# WATER QUALITY MEMORANDUM

RE: 3<sup>rd</sup> Quarter 2019 Water Monitoring, Genwal Resources, Inc., Crandall Canyon Mine, C/015/0032 Task ID #5941

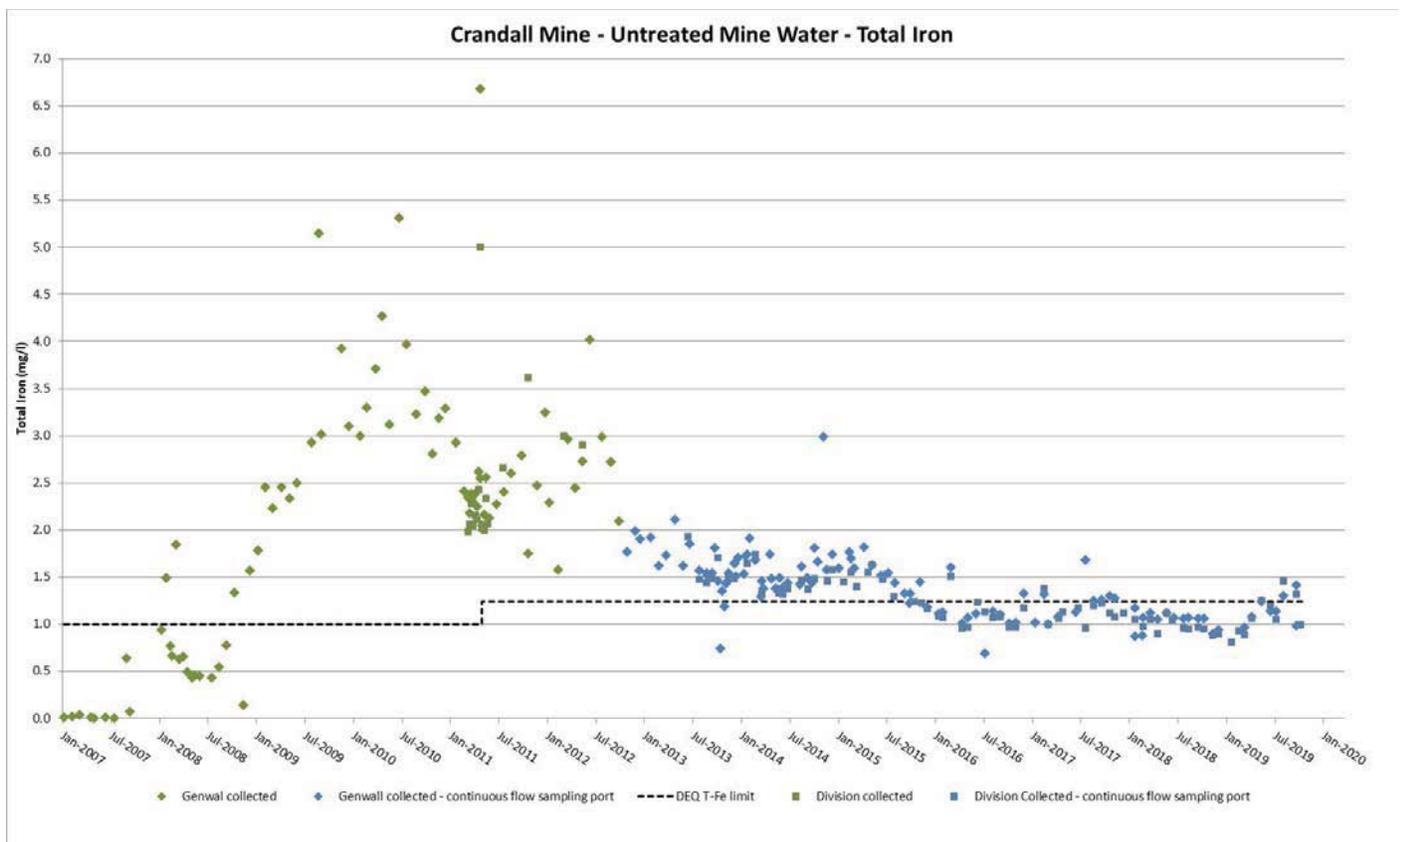
\*\*As the total iron concentrations in the mine-water discharge began to increase, a concern was that a similar rise would be observed in stream monitoring site LOF-1 (lower Crandall Canyon flume). An upward trend of total iron began to surface the second quarter of 2008 in correspondence with the increase in iron concentrations of the mine-water discharge. A total iron concentration of 1.479 mg/L was reported the Fourth Quarter of 2009. Once the mine-water treatment system became operational

during the First Quarter of 2010, the iron concentrations detected at LOF-1 have dropped significantly. The total iron concentration for LOF-1 this quarter was 0.67 mg/L.
